Greenpark.

## CONSTRUCTION SUMMARY RECEIVED

Red Oaks - Roundel Homes Inc.

LOT / PHASE	REG. PLAN #	HOUSE TYPE		£
77 / 2	65M-4737	Pinetree 3 Elev 3		
CONSTRUCTION				
1 - FRAMELESS GLASS SHOWER ENCLOSURE PROVISION - REMOVE SIDE WALL AND REPLACE WITH GLASS TO ACCOMODATE FRAMELESS GLASS SHOWER ENCLOSURE SEE SKETCH 01May23 Note:				
1 - SMOOTH CEILINGS ON SECOND FLOOR				
01May23 Note:				
1 - SMOOTH CEILINGS ON FIRST FLOOR  01May23 Note:				
ELECTRICAL				
1 - STANDARD DINING ROOM LIGHT TO BE CENTERED BETWEEN LIVING AND DINING ROOM  01 May 23 Note:				
1 - ABOVE KITCHEN ISLAND - ADD LIGHT AND SWITCH - NO FIXTURE INCLUDED				
01May23 Note:				
MIRRORS AND GLASS				
1 - SHOWER DOOR HANDI 01May23 Note:	LE - CHROME D-RING	TOWEL BAR COMBO		
1 - MASTER ENSUITE - FR	AMELESS GLASS SHO	OWER ENCLOSURE – INCLUDES CHROME KNOB ANI	DHDIGES	
01May23 Note:	WELLESS GENOS SIRC	WER ENCEOSORE - INCEODES CHROWE KNOB AND	DHINGES	
PROMOTIONAL				
1 - LESS CREDIT FROM PU	RCHASER EXTRA SH	EET IN OFFER		
01May23 Note:

## Pinetree 3

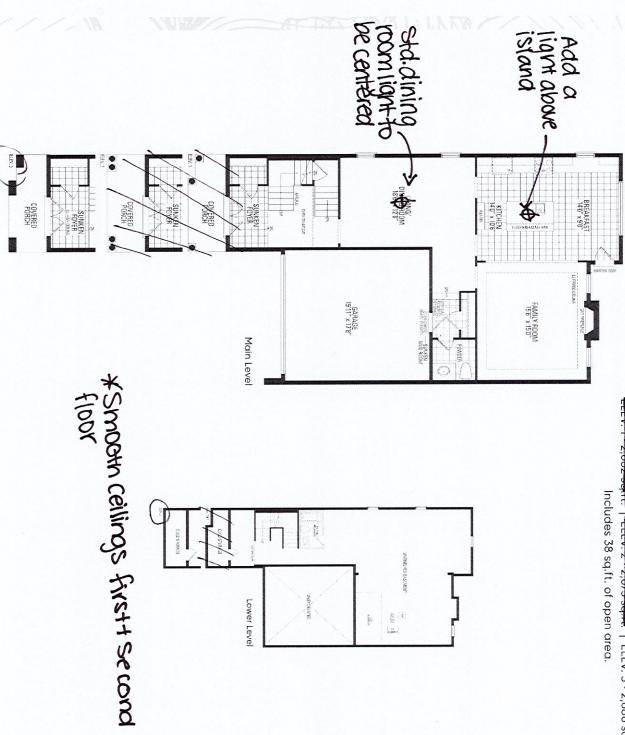
Frameless glass snower enclosure
